AIRPORT LAND USE COMMISSION

ANNUAL MEETING AGENDA

MEMORANDUM

To:	Airport Land Use Commission (ALUC)
From:	Fionna Jensen, ALUC staff, May 10, 2024 (831) 796-6407
Meeting Date:	May 20, 2024
Subject:	Scheduled Item 7a – County of Monterey (York School) Proposed improvements to an existing high school athletic field, including installation of synthetic turf, ball netting, an all-weather track, and an upgraded drainage system (24CP00599).

Figure 1. ALUCP Exhibit 4B and 4C (Long Range Noise Exposure Contours and Airport Safety Zones). The subject property and proposed project site (athletic field) are outlined in red dashed lines.

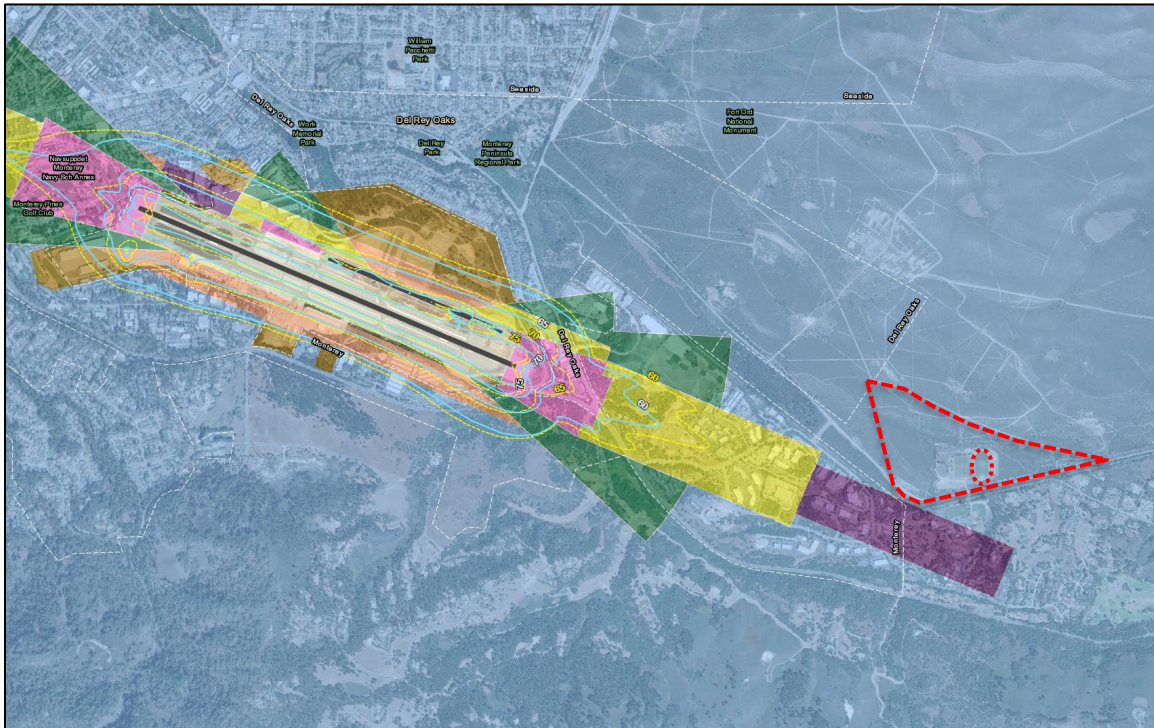
The subject property is located approximately 8,760 feet east of Monterey Regional Airport Runway 28L. The subject property is located within Safety Zone 7, which allows for all uses except hazards to flight, outdoor stadiums, and other similar high-intensity uses. The existing field has three single-bench portable bleachers; these will be retained and re-used.

No additional seating is proposed. Safety Zones 2 through 5 prohibit schools, while the establishment of a school could be a compatible use within Safety Zone 7. The existing and proposed replacement athletic field is an accessory to York School and will not be used by any other sports club or the public and therefore will have an overall low and limited intensity. Thus, as a high school athletic facility used solely by York School, staff does not consider the existing or proposed athletic field to be an “outdoor stadium.” Based on this determination, the existing and proposed replacement athletic facility is allowed with a compatible intensity within Safety Zone 7.

Figure 2. ALUCP Exhibit 4E (Part 77 Terrain). The subject property is outlined in a red line.

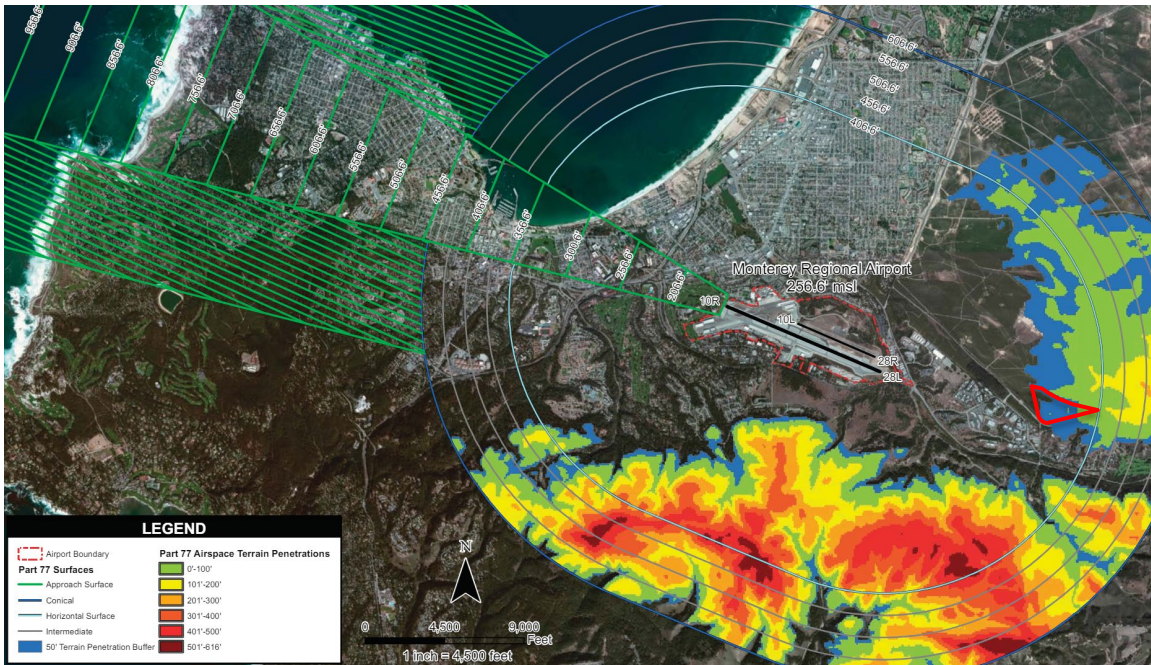
As shown in the above figure, a majority of the subject property is within the “50-foot Terrain Penetration Buffer” which means that the property has elevations that are within 50 feet of 406 feet. Although the eastern portion of the subject property has elevations in excess of 406 feet AMSL (green areas shown in Figure 2), the existing athletic field has elevations ranging between approximately 401 and 404 feet AMSL. The replacement synthetic turf, all-weather turf, and drainage improvements will maintain their existing elevations (below 406 feet AMSL). However, the top of the proposed ball nets (netting to stop stray balls from being kicked, hit, or thrown off the field) encroach into Part 77 surfaces by 15 feet. The 20-foot-tall ball nets will have top elevations of approximately 421 feet above AMSL. Policy 4.2.3.2(e) of the ALUCP prohibits new structures on terrain that already penetrates Part 77 surfaces. All development is proposed on terrain that is below Part 77 surfaces (406 feet AMSL).

The ALUCP (Policy 4.2.3.2) requires that projects that penetrate or have the potential to penetrate Part 77 surfaces obtain a ‘Determination of No Hazard to Air Navigation’ from the Federal Aviation Administration. This determination, which can take between 45 days and 3 months to obtain, is required to be submitted with the ALUC application materials. In this case, York School has received a ‘Determination of No Hazard to Air Navigation’ from the FAA for a future development proposal that contemplates lighting being installed around the athletic field (**Attachment C**). The FAA’s determination concluded that “the proposed structures [future lighting proposal] would penetrate the MRY Horizontal surface; however, it would not conflict with airspace required to conduct normal VFR [visual flight rules] traffic pattern operations” (**Attachment C**). It is important to note that this future proposal is not under the purview of the ALUC as it is not part of this application and is only referenced for analytical purposes. The following analysis does not serve as a consistency determination for any future proposal on the subject property.

Figure 3. Heights of future lighting proposal (pink) vs. proposed ball netting (orange).

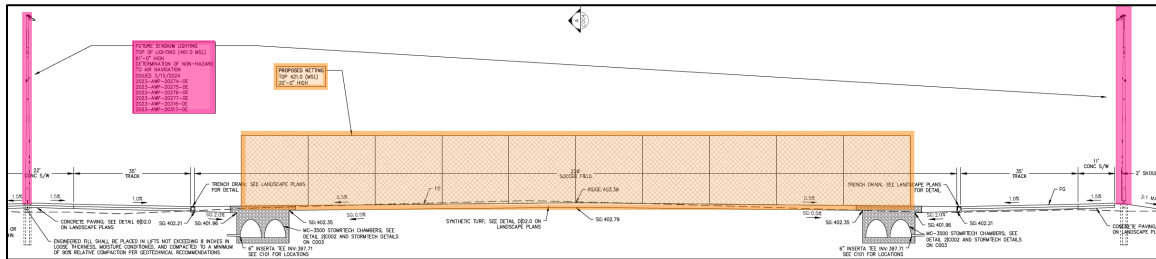
The future lighting proposal has a top height of 461 feet AMSL and would be located in close proximity to the proposed ball nets (located at the north and south ends of the replacement athletic field), which will have a top height of 421 feet AMSL (see **Attachment D** and Figure 3). The future lighting proposal’s height exceeds Part 77

surfaces by 55 feet while the proposed ball net height exceeds Part 77 surfaces by 15 feet. York School has requested that the requirement to obtain the FAA Hazard Determination be waived because the future lighting proposal is taller than the proposed ball nets and has received a ‘Determination of No Hazard’. However, due to the clear language of Policy 4.2.3.2, staff has applied a condition of approval (ALUC-9) that requires the ‘Determination of No Hazard’ to be obtained and submitted to ALUC staff prior to installation of the ball nets. This approach would allow York School to replace the turf field with synthetic turf, modernize the dirt track with an all-weather track, and upgrade the drainage systems while it obtains the FAA Hazard Determination. If a Determination of No Hazard is obtained, York School can install the ball nets.
